PROJECT: SES Solar One

- The Applicant's Responses to CURE Data Requests, Set One

In Response to CURE Data Requests
Set I: Data Requests 1-228

Application for Certification (08-AFC-13)

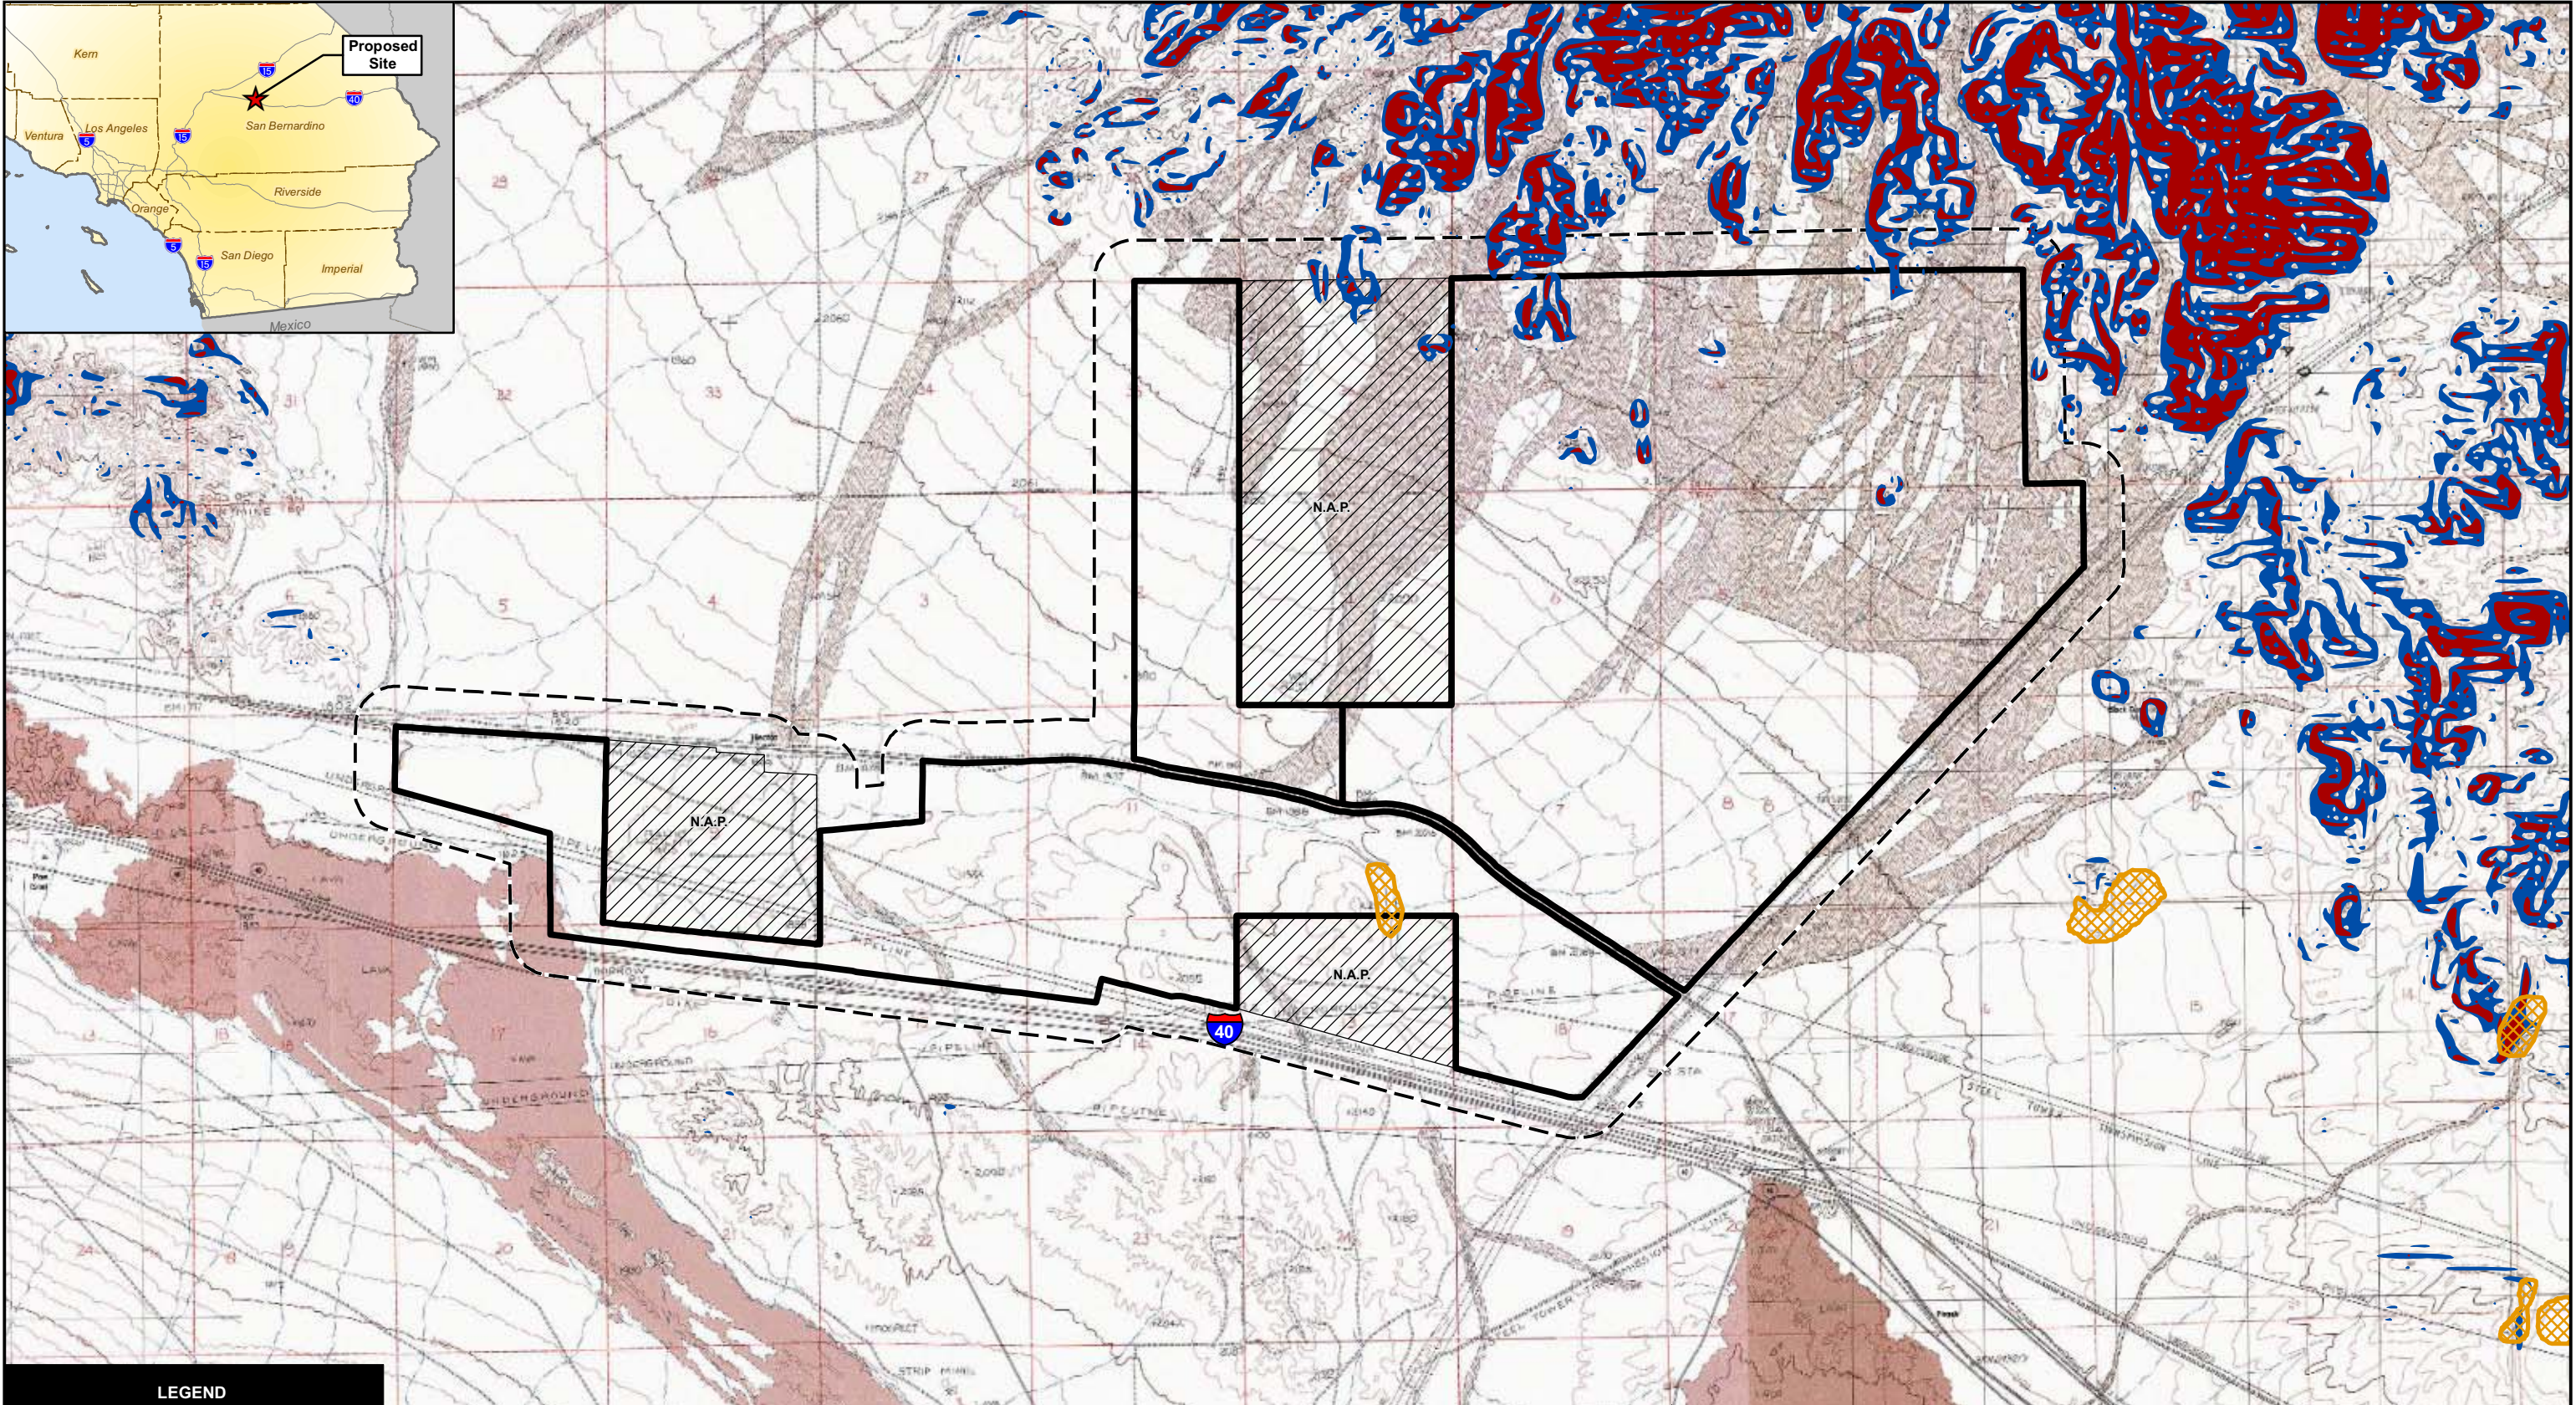
Data Request 22: Please explain how desert tortoise habitat suitability was determined and quantify the modifier “majority” (in reference to the majority of the AFC Assessment Area being suitable habitat). (*Id.*)

Response: Only tortoise individuals and burrows that were detected and deemed active during the sample plot surveys were used in the estimate. Incidental sightings not recorded as part of a plot survey are not relevant to the calculation of density. Sample plot coverage is 33% (80 acres surveyed per 240-acre cell). Detection rates of 55% and 100% were used to provide the full range of the estimate. There is no inconsistency between the estimates and maps provided in the AFC.

Response: Most of the site supports vegetation and soils deemed suitable for tortoise occupation based on consideration of desert tortoise habitat requirements. Steep, rocky areas and sand dune areas are least suitable for tortoise use. About 1.7% of the site is less suitable for tortoise. A figure showing habitat not suitable for tortoise use is provided as attachment BIO-1, located behind this response.

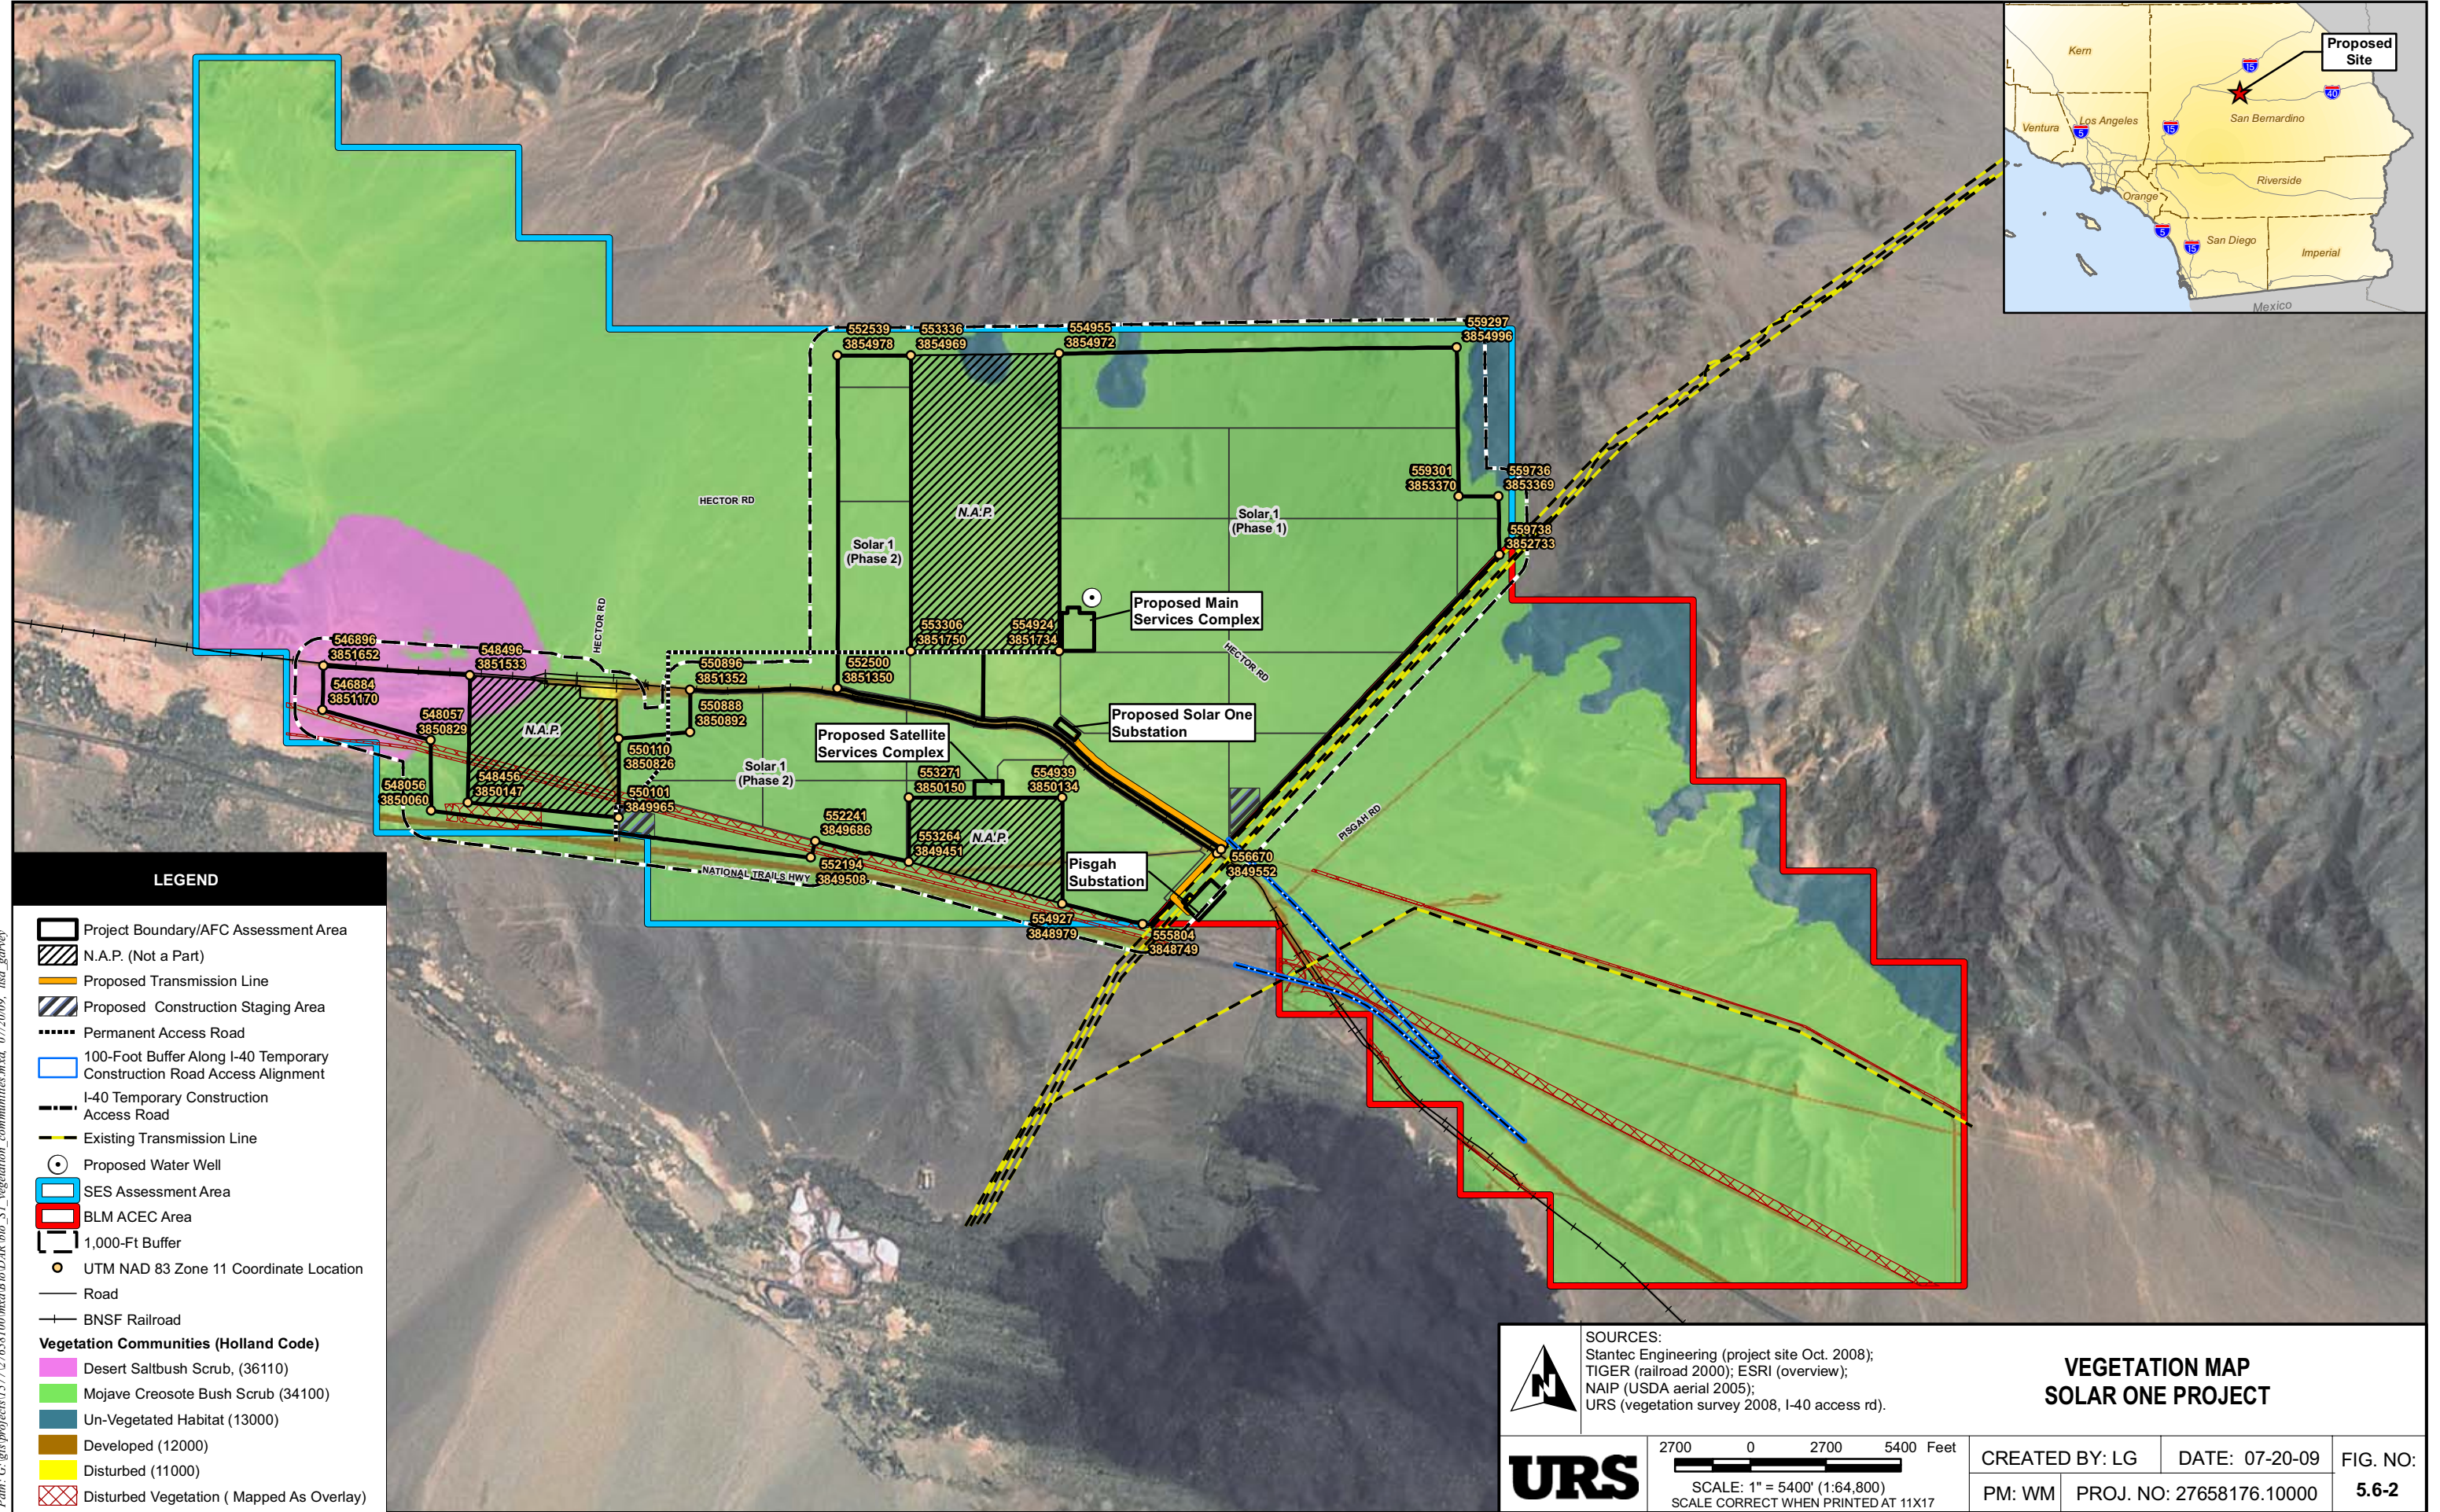
Data Request 225: Please provide a map of the Project site that indicates the UTM coordinates of Project boundaries.

Response: UTM coordinates of the Project boundaries have been included on Figure 5.6-2 of the AFC, provided behind this response as attachment BIO-4.

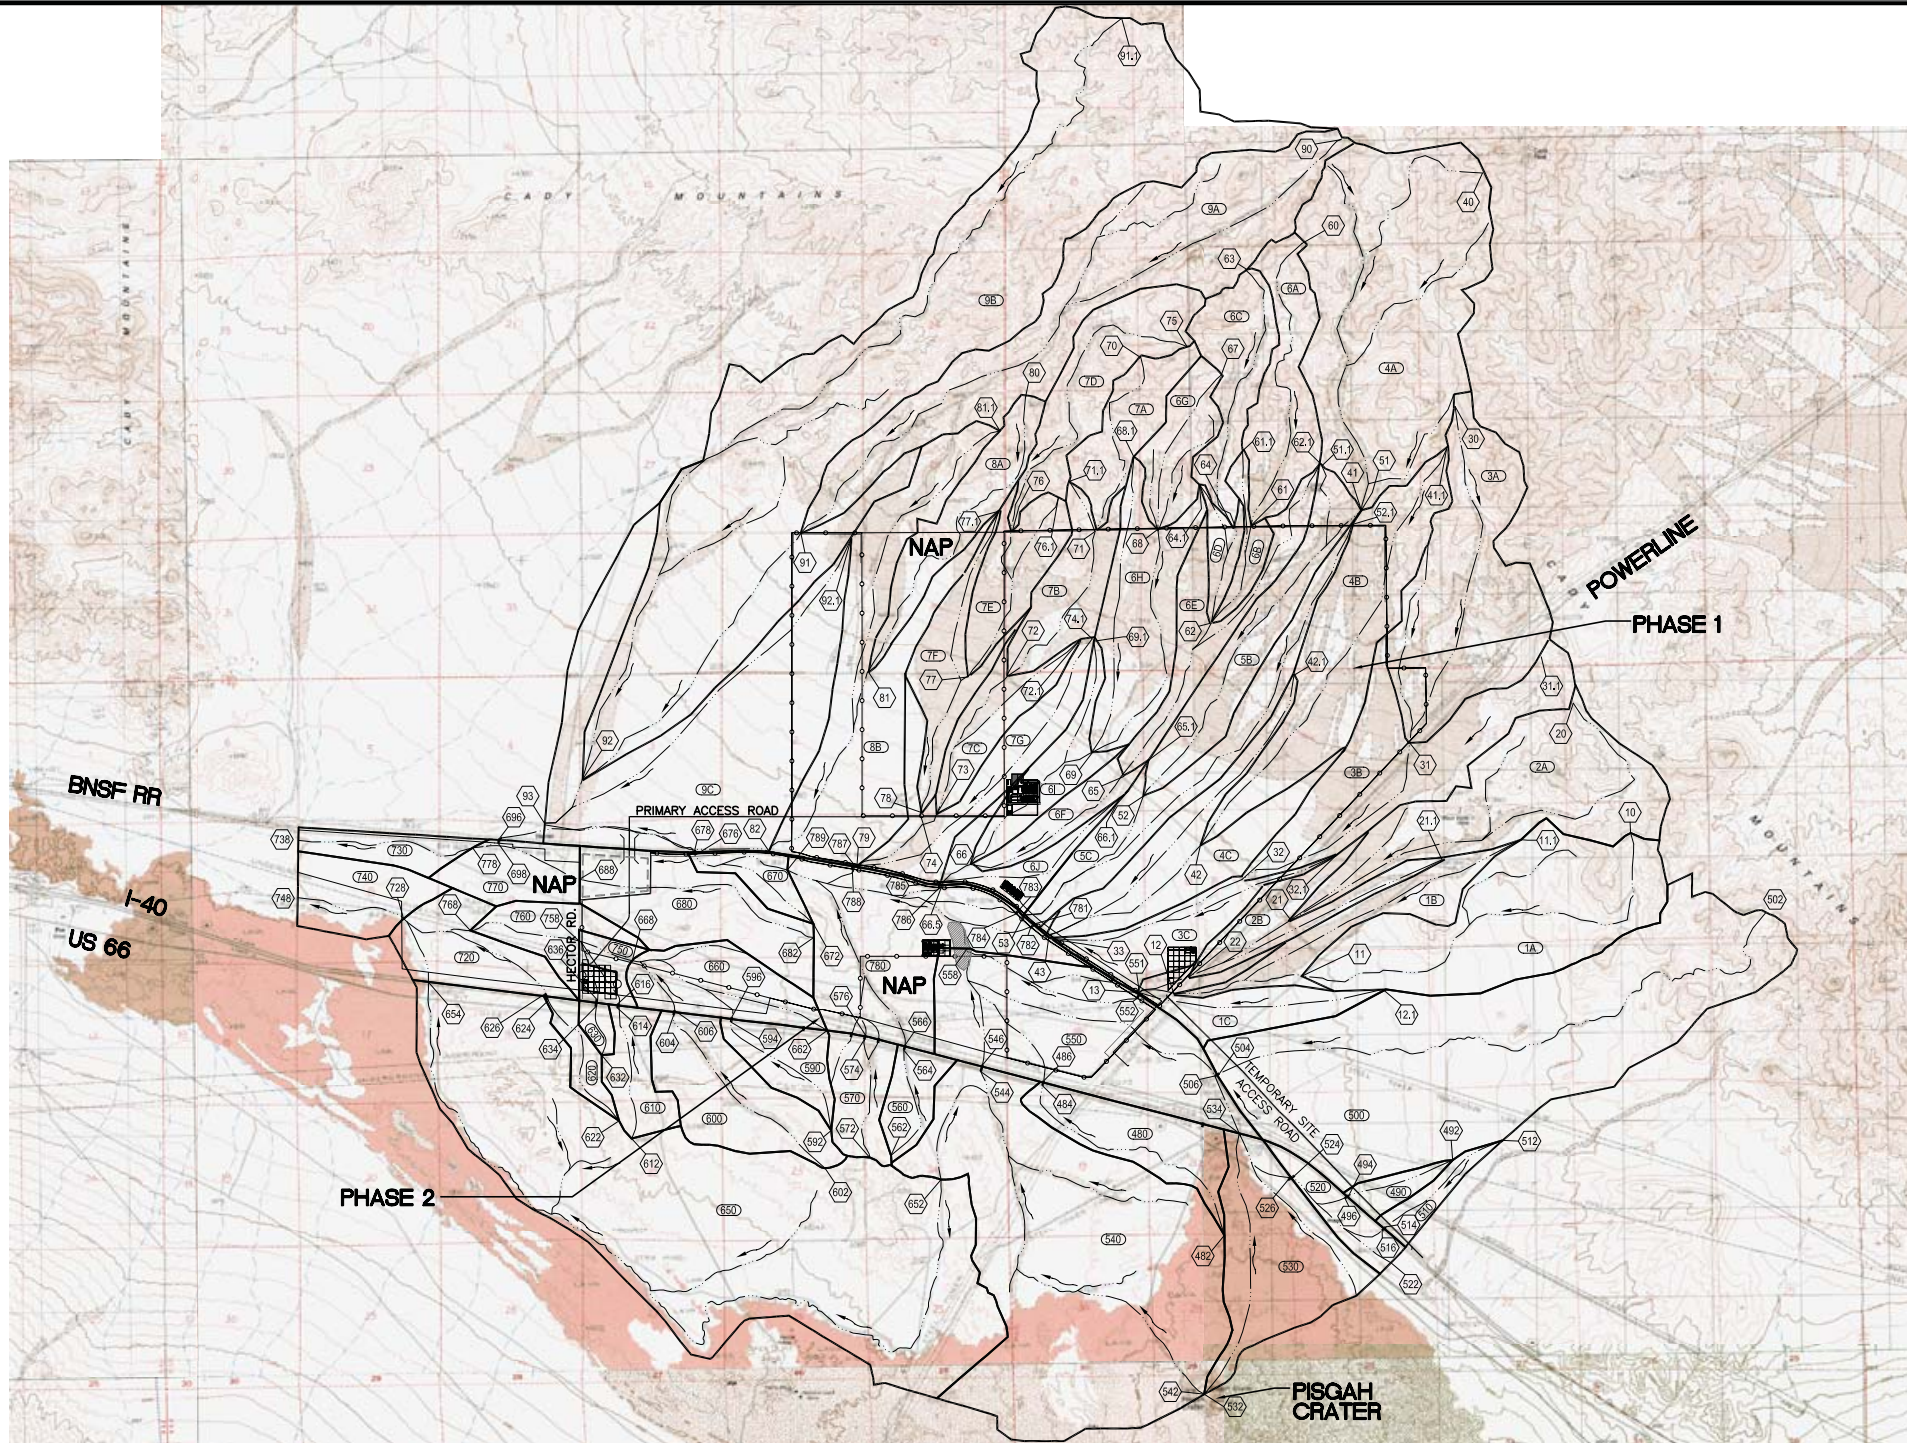
Data Request 226: Please provide information on the anticipated amount of Project-related ground disturbance within the BLM ACEC.

Response: The new substation is in the ACEC based on current understanding, and is estimated to require 40 acres of disturbance.
